SUBJECT: THREE MILE ISLAND UNIT-2 INDEPENDENT SPENT FUEL STORAGE
INSTALLATION INSPECTION REPORT 07200020/2018-001

Report Number: 07200020/2018-001

Facility: Three Mile Island Unit 2 Independent Spent Fuel Storage Installation

Figure 1 TMI-2 ISFSI

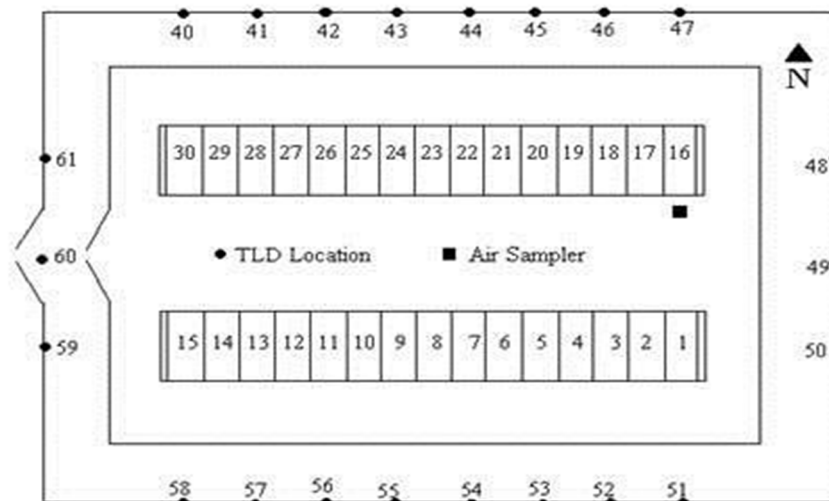
Thirty HSMs were situated on the TMI-2 ISFSI pad. Twenty-nine were loaded with spent fuel debris from the TMI-2 reactor. One additional HSM was placed on the pad with an oversized overpack installed to serve as a backup in case one of the DSCs developed a leak and needed confinement. The 30 HSMs were arranged in two rows of 15 with door openings facing inward, numbering 1–15 on the south row and 16–30 on the north row, going east to west (see Figure 1, above).

The walk-down of the ISFSI pad found the concrete to be in good condition. There was no overt vegetative growth in or around the pad. No flammable or combustible materials were observed on the ISFSI pad. There was a low volume air sampler situated on the ISFSI pad in close proximity to HSM #16 that was used as part of the periodic airborne radioactivity sampling process to assess airborne radiological environmental impacts due to TMI-2 ISFSI operations. The material condition of the 30 HSMs was observed to be acceptable. Signs of repairs made to the concrete were evident on many of the storage modules. The repairs were intact and appeared to be free from further degradation. All of the inspected hardware, doors, latches, and ports installed in the TMI-2 HSMs were in good condition.
